# Staff Report

## Tentative Subdivision Plat and Minor Variance

SD-03-23 & VR-03-24

April 30, 2024

**TENTATIVE PLAT  
 PLAN**

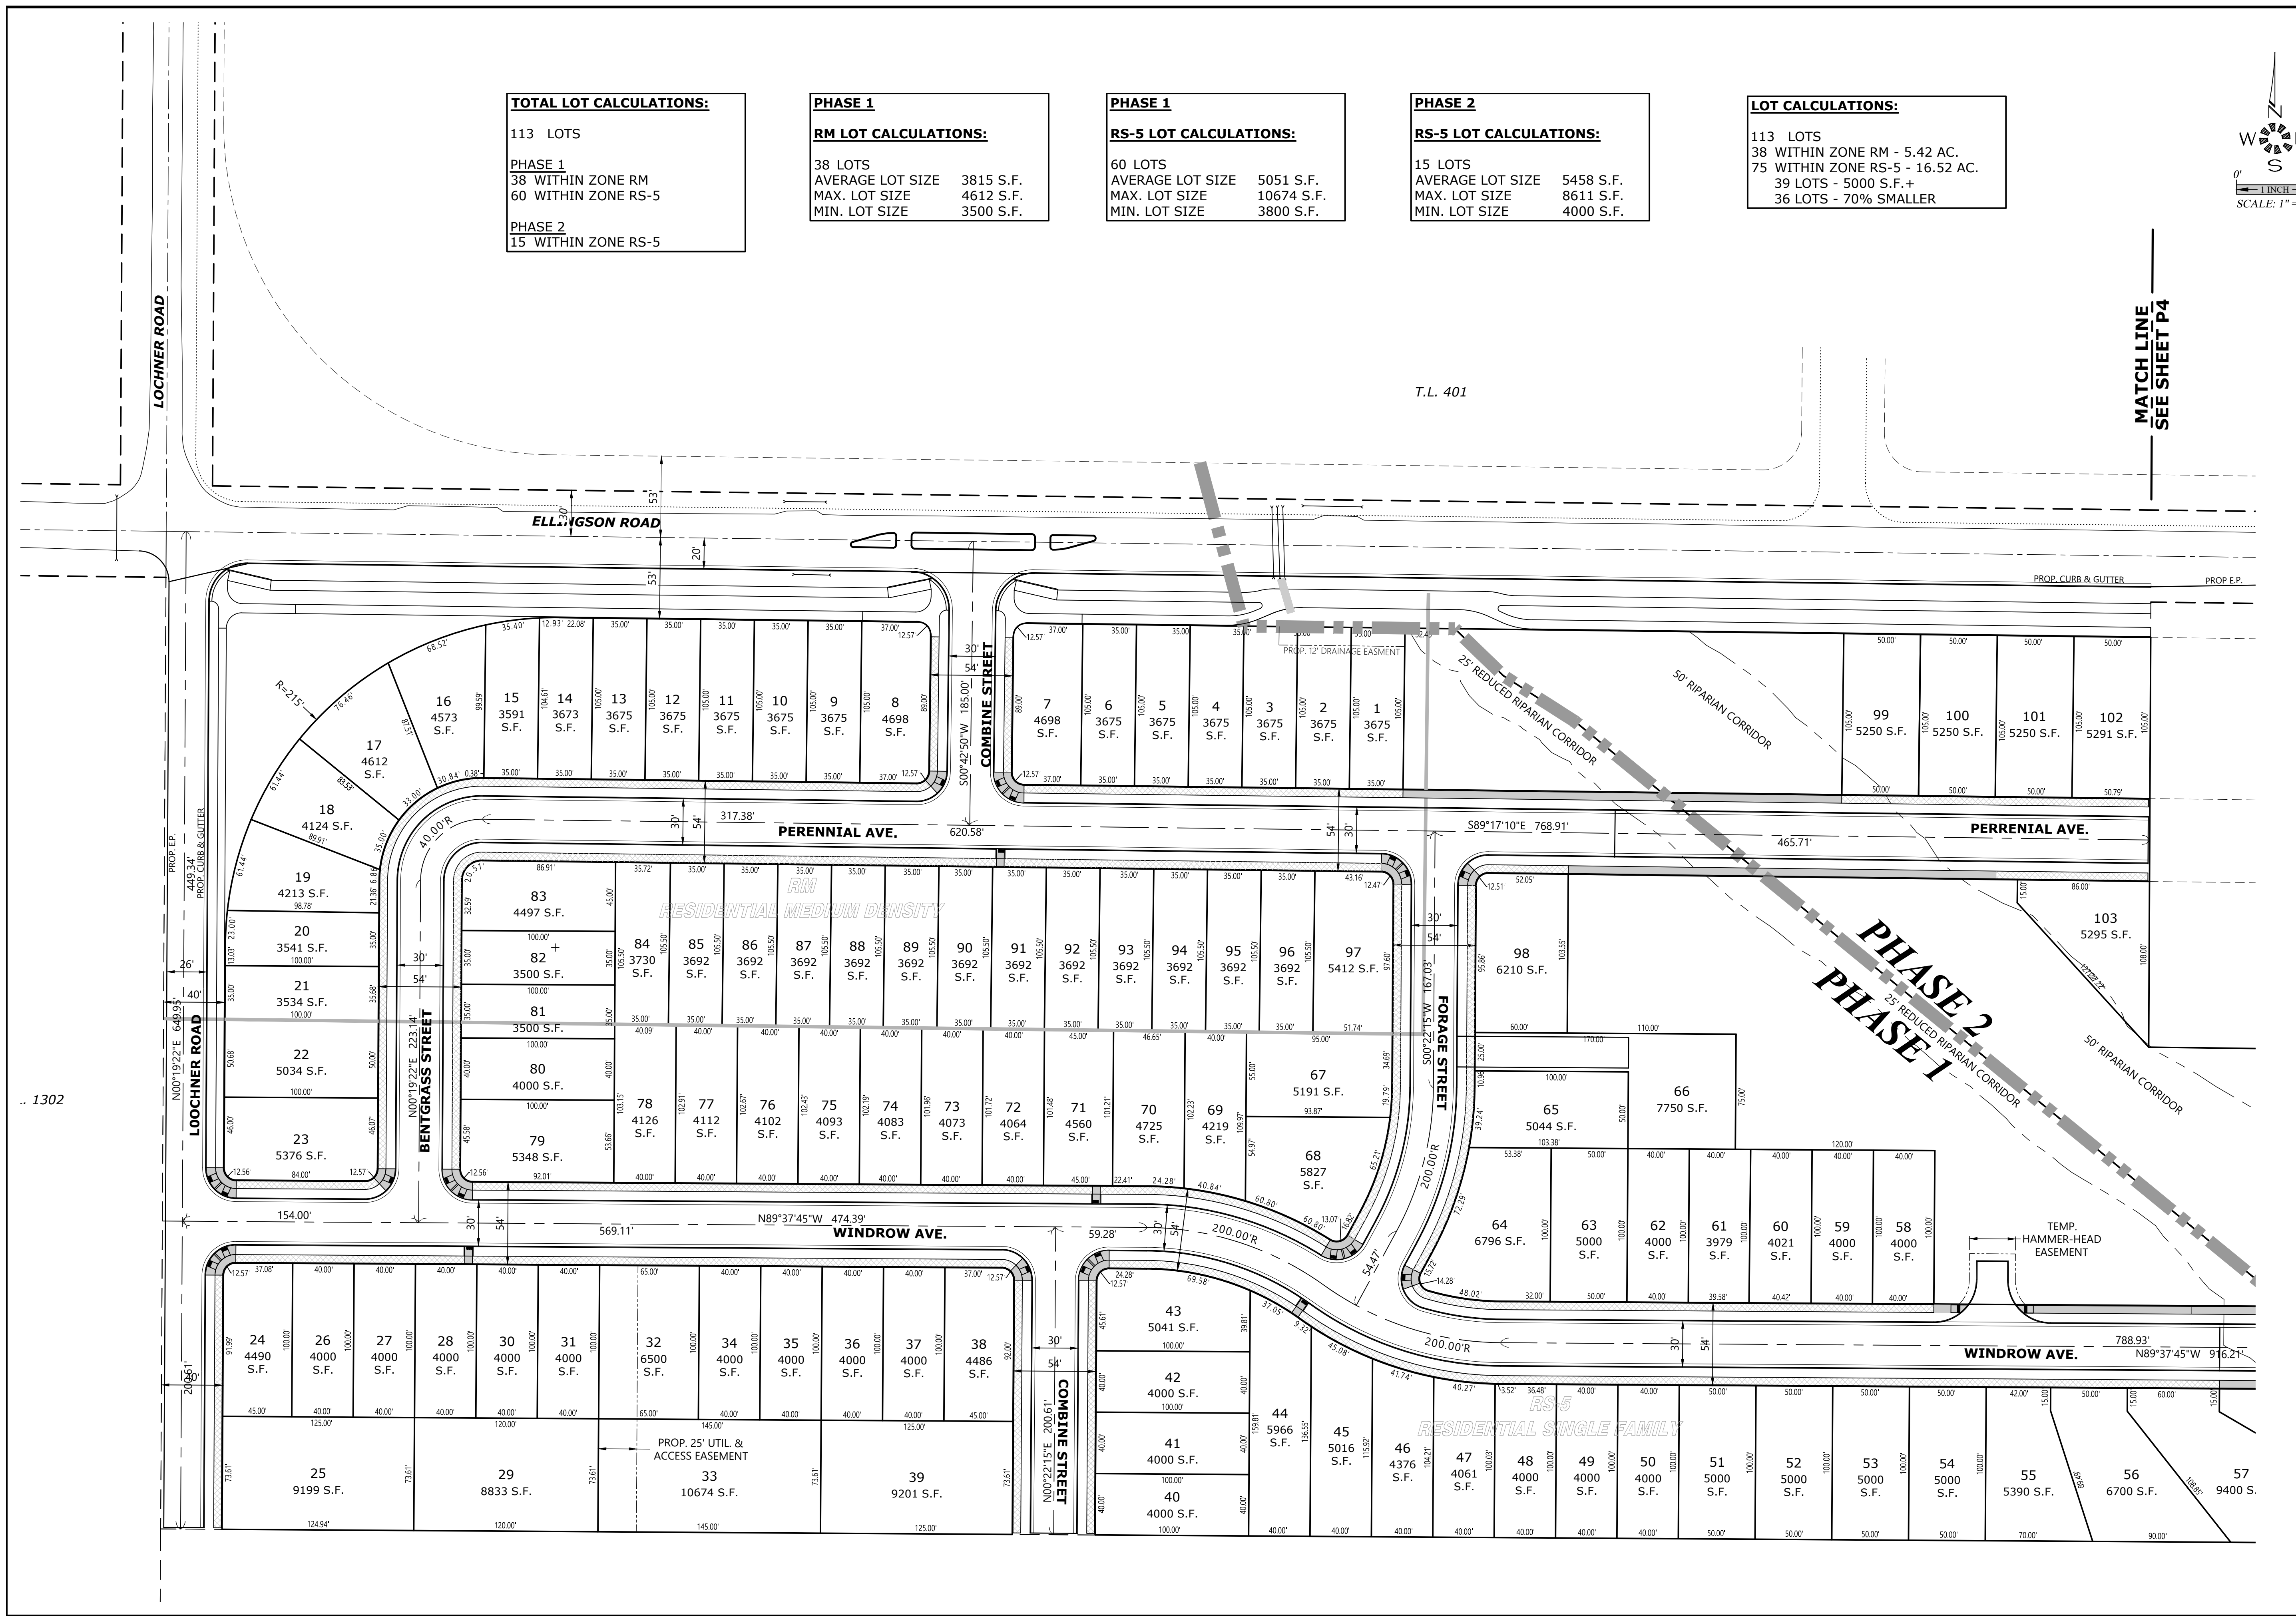
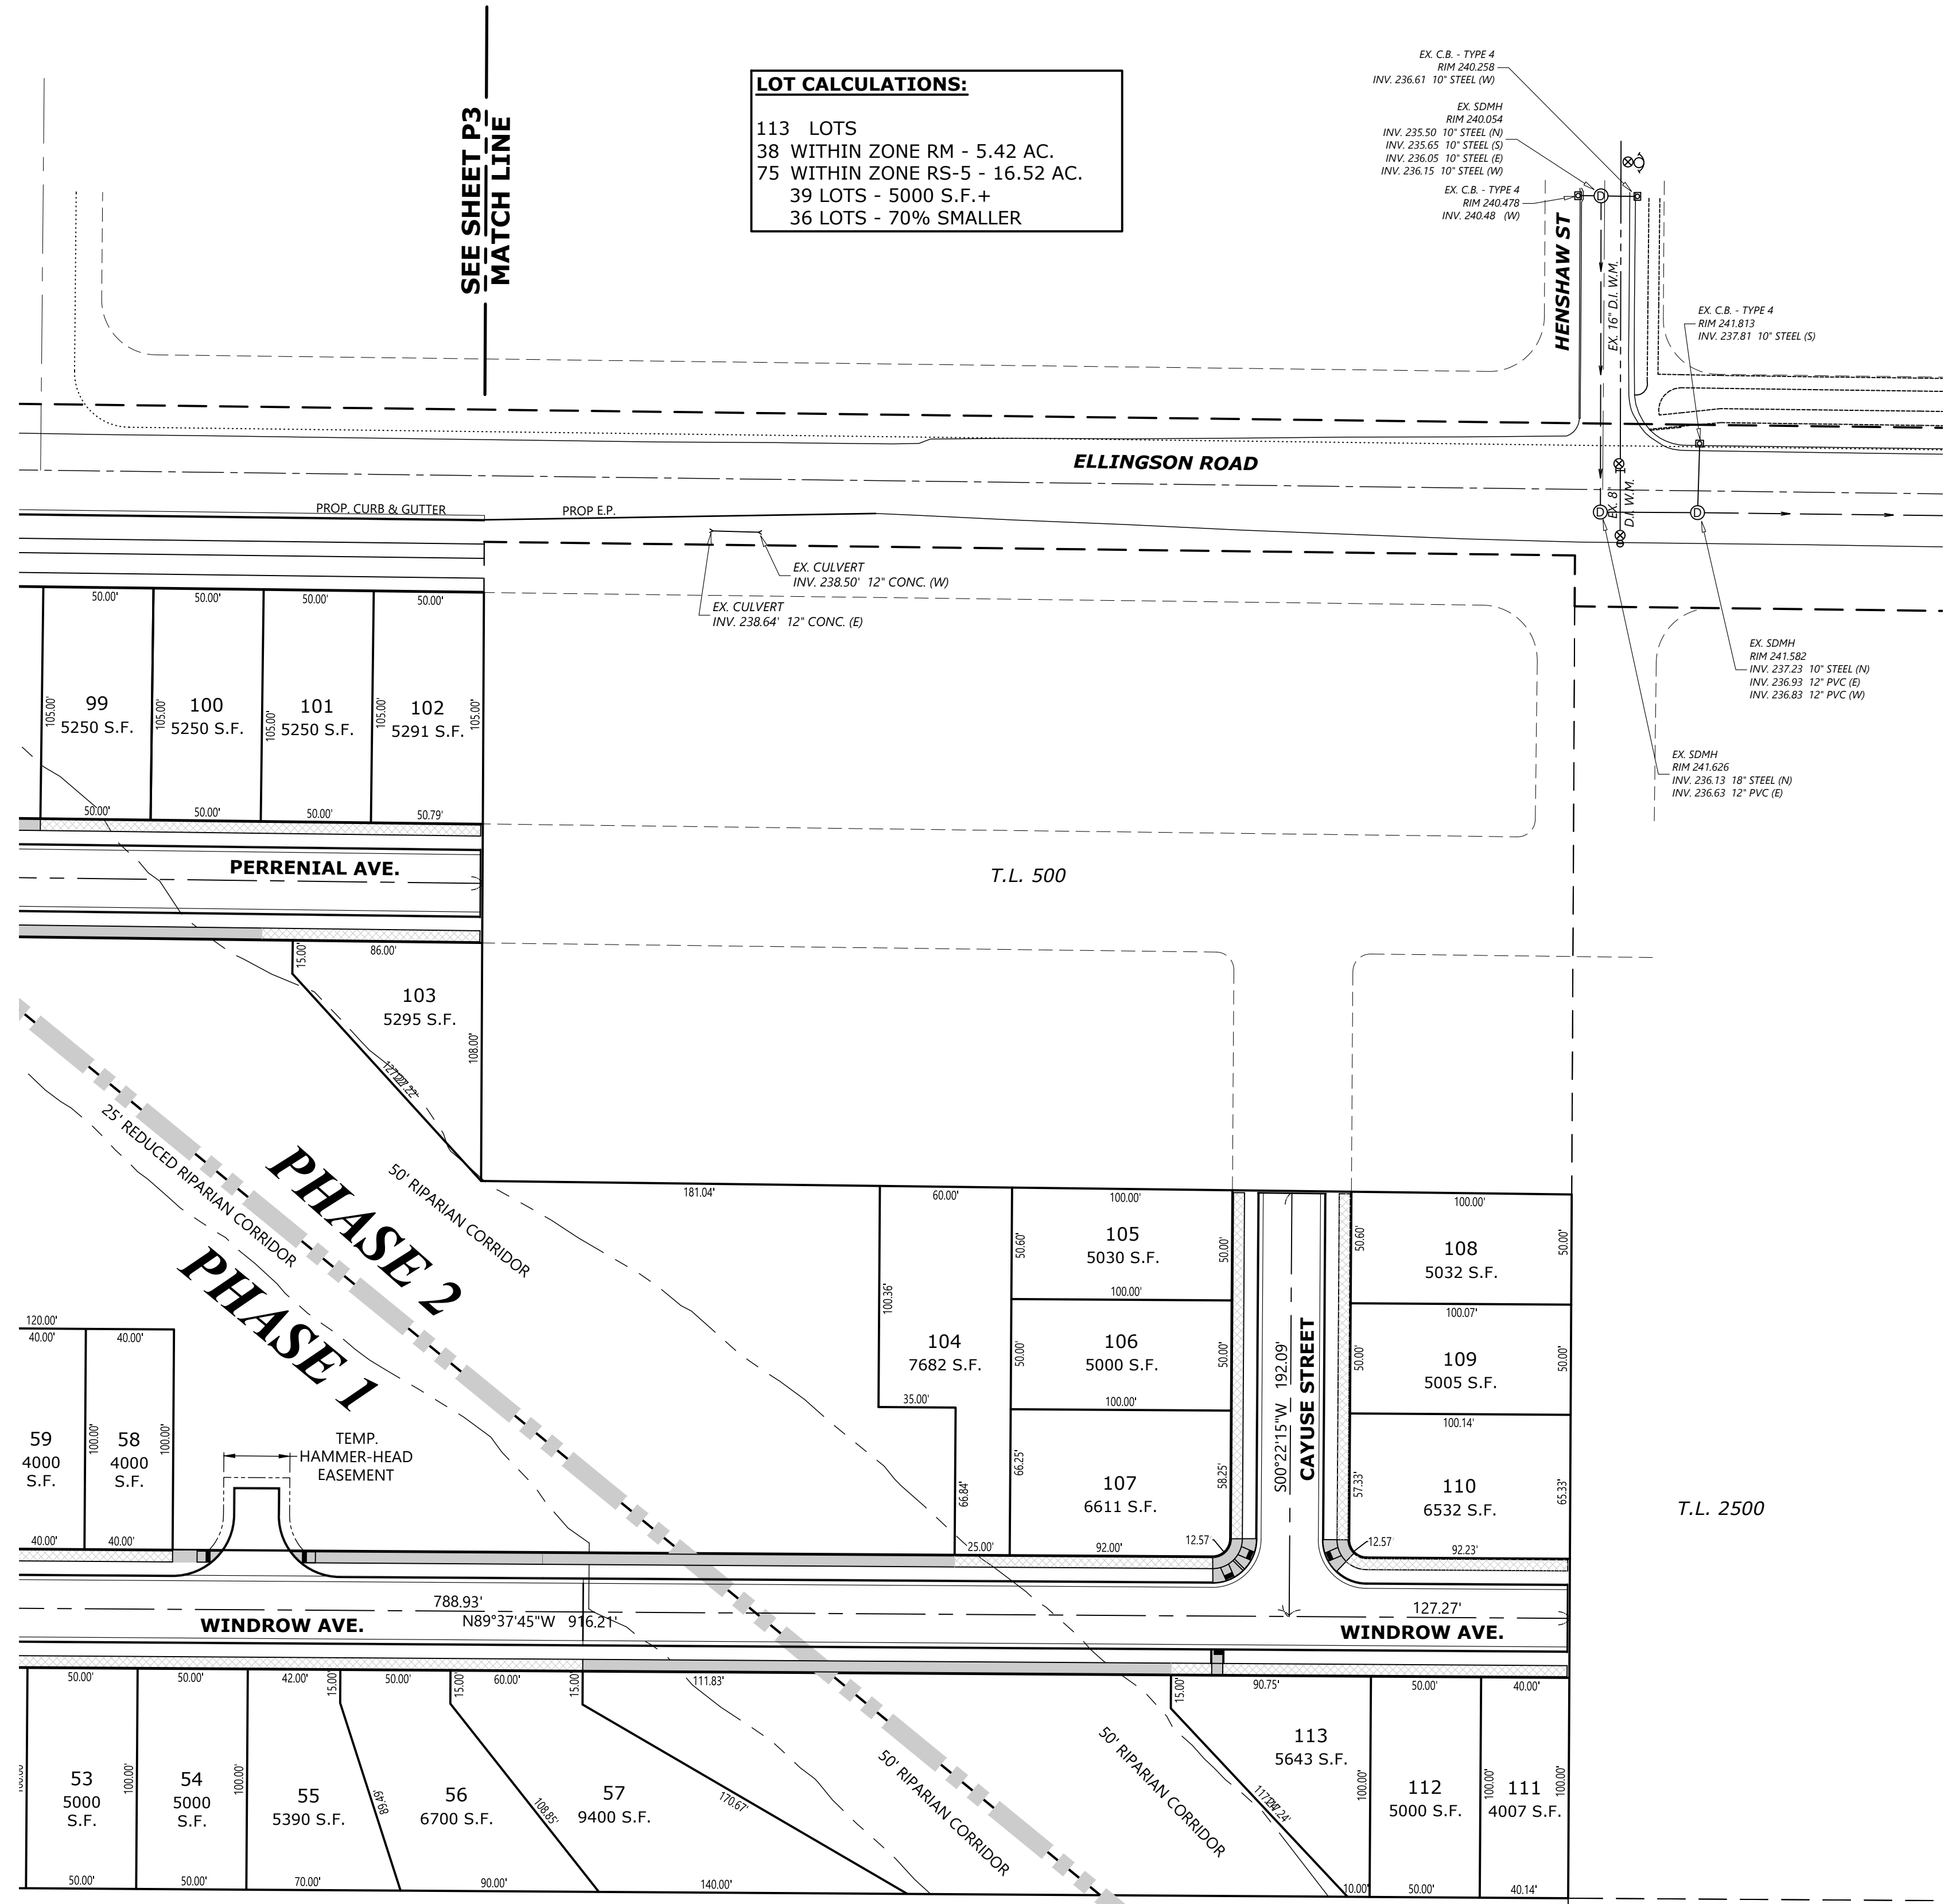
- 3.2 As shown on the Tentative Plat (Attachment B), the proposed development would develop six new local streets within the subdivision, Combine Street, Perennial Avenue, Bentgrass Street, Windrow Avenue, Forage Street, and Cayuse Street. Perennial Avenue and Cayuse Street are configured to provide 1252 Ellingson Road internal connections in the future. Combine Street is configured to provide access to the south if development is proposed in the future.

- 4.4 Right-of-way dedication is needed along the site's frontage on Ellingson Road in order to allow for the improvement of the street in accordance with the city's TSP and the SAAP. The tentative plan map submitted by the applicant provides for right-of-way dedication needed for both the street improvement as well as the future roundabout at the Ellingson Road/Lochner Road intersection.

- 4.9 The development of Phase 1 will result in Windrow Avenue extending and temporarily dead-ending approximately 600 feet east of its intersection with Forage Street. The applicant has proposed construction of a temporary hammerhead with Phase 1 in order to provide for turnaround movements by residents and emergency vehicles.

- 4.10 The internal street system proposed by the applicant includes a 90-degree corner at the Bentgrass Street/Perennial Avenue intersection that could limit the ability of emergency vehicles to navigate the corner. Potential treatments to avoid that result would include redesigning the intersection to include a "knuckle" or modifying the radius of the inside and outside curbs to add additional width through the intersection.

- Condition 10** A temporary hammerhead shall be installed on the north side of Windrow Avenue just west of Lot 58 as shown on the approved site plan. The hammerhead shall be striped and posted "No Parking".

- Condition 23 Prior to the signing of the Final Plat the applicant shall provide an urban conversion plan indicating how Lot 33 can further be divided.

- Dedicate right-of-way for construction of a roundabout at the Lochner Road/Ellingson Road intersection as shown on the approved tentative site plan.
- Condition 4** Prior to recordation of the final plat map, the applicant shall provide a Petition for Improvement/Waiver of Remonstrance for construction of non-roundabout related street improvements to Ellingson Road.

- Condition 5** Prior to recordation of the final plat map, the applicant shall provide a financial contribution of the site's contribution to the future construction of a roundabout at the Lochner Road/Ellingson Road intersection. The amount of the contribution shall be one eighth of the adjusted total project cost of project I41 in Albany's 2010 Transportation System Plan. The adjusted project cost shall be determined by using the Engineering New Record (ENR) Construction Cost Index (Seattle) between February 2010 and the date of map recordation.
